Access Compliance Report Public Rights-of-Way (Curb Ramps)

Intersection ID: 28418 Main Street: AMBRIDGE DR Cross Street: CHASTAIN_WALK_DR Location: SW **Severity Score:** ADA ID: 4363D6413886 Ramp Type: Perp Initial Pass/Fail: Fail **Overall Compliance: No** 12.5

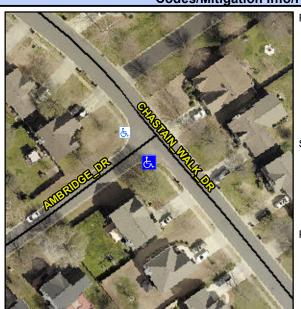
Possible Solutions: Remove & Replace Entire Ramp. Surveyor Notes: N/A PROW/ADA: Not Found, R304.2.2

Field Measurements/Component Compliance						
Compliance Description		Data	Comp	liance	Description	Data
N/A	Ramp Length (in)	51.0	No	Ram	Slope (%)	8.8
Yes	Ramp Width (in)	56.0	Yes	Ram	xSlope (%)	0.3
N/A	Flare Type LT	N/A	N/A	Flare	Type RT	N/A
N/A	Flare Slope LT (%)	N/A	N/A	Flare	Slope RT (%)	N/A
N/A	Flare Traversable LT?	N/A	N/A	Flare	Traversable RT?	N/A
N/A	Landing Length (in)	N/A	N/A	DWS	Provided?	N/A
N/A	Landing Width (in)	N/A	N/A	DWS	Contrast?	N/A
N/A	Landing Slope (%)	N/A	N/A	DWS	Length (in)	N/A
N/A	Landing X Slope (%)	N/A	N/A	DWS	Full Width?	N/A
N/A	Landing Curb? (Y/N)	N/A	N/A	DWS	Offset (in)	N/A
N/A	Shared Landing?	N/A				
N/A	Gutter Ponding?	N/A	N/A	Gutte	er Slope (%)	N/A
N/A	Gutter Lip Ht (in)	N/A	N/A	Gutte	er X Slope (%)	N/A
N/A	Painted X Walk1?	No	N/A	Paint	ed X Walk2?	N/A
	X Walk 1 Direction	To NW		X Wa	lk 2 Direction	N/A
N/A	X Walk 1 Width (in)	N/A	N/A	X Wa	ılk 2 Width (in)	N/A
	X Walk 1 Slope (%)	0.2		X Wa	ılk 2 Slope (%)	N/A
